The following modifications should be made to the C2s:

Regarding C2s circuit modifications 1 - 4:

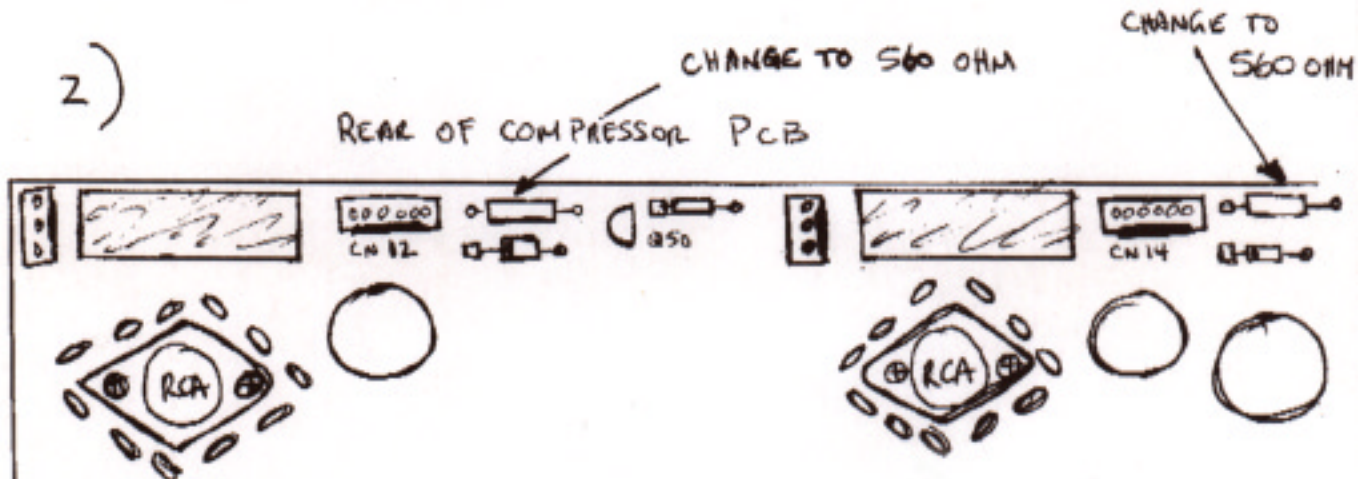
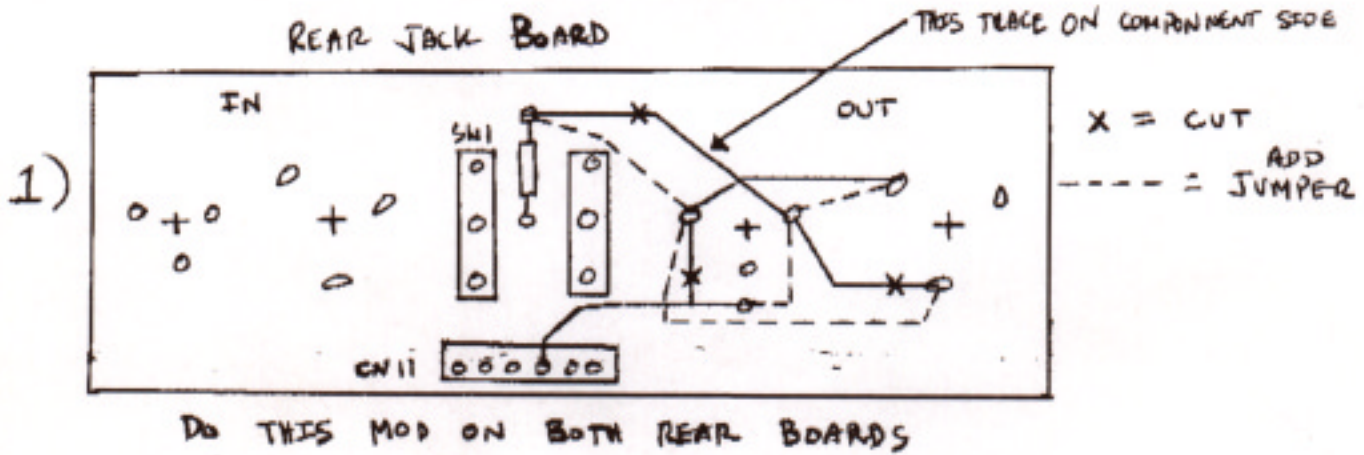
- 1.) For serial numbers 1016 and below (some of you may have already done this); corrects error in board layout affecting XLR jacks.
- 2.) For serial numbers 1018 and below (some of you may have already done *this*); reduces improper high voltage to relays.
- 3.) For serial numbers 1027 and below; reduces input gain making input control less sensitive (optional).
- 4.) For serial numbers 1025 and below (this resistor may be present on some units); improves taper on output control.

JT/RE - 11P - 1T

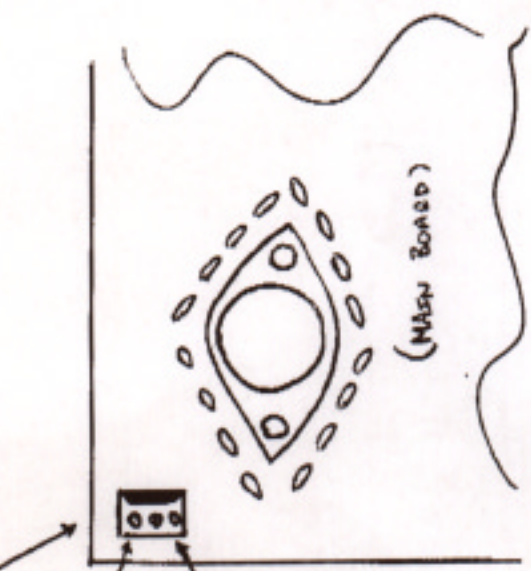
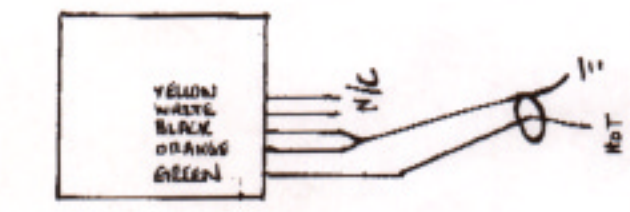
NOTE DIFFERENT COLOURS FOR DIFFERENT INPUT TRANSDUCERS USED.
 YOU WILL NOT NEED TO CHANGE ANY WIRING ON INPUT TRANSFORMER

MAKE SURE THIS IS CORRECT

TO MAIN BOARD "INPUT"

JT/RE - 11P - 1

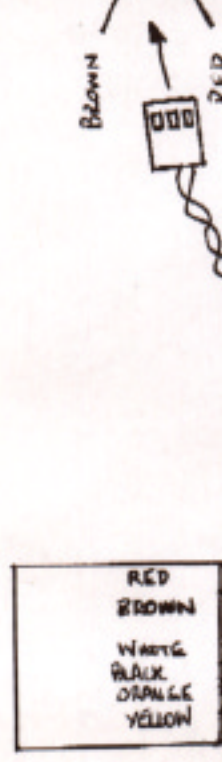
ADD 30K-40K RESISTANCE ACROSS THESE TWO LEGS OF THE OUTPUT POT. THESE WILL BE TAPS AVAILABLE FOR INSERTING THE PRESS-TOOL AT THE BOTTOM OF BOARD

CHECK THIS WIRING CORRECT IF NECESSARY

ADD 4.9K RESISTOR MORE RESISTANCE LESS (GREEN)

4)

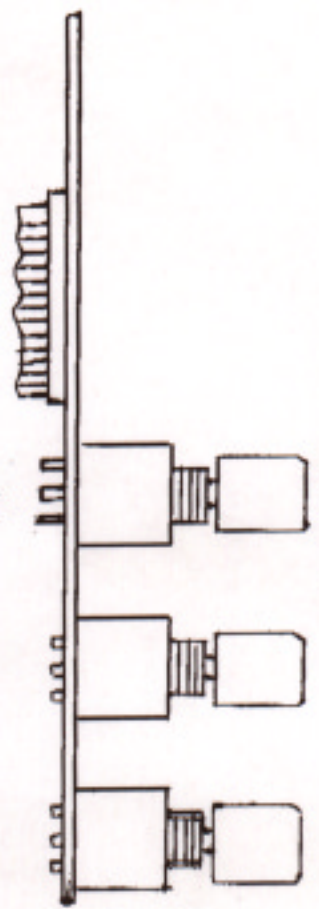
DO ON BOTH OUTPUT CONTROLS

DO ON BOTH INPUT CONTROLS

CUT TRACE
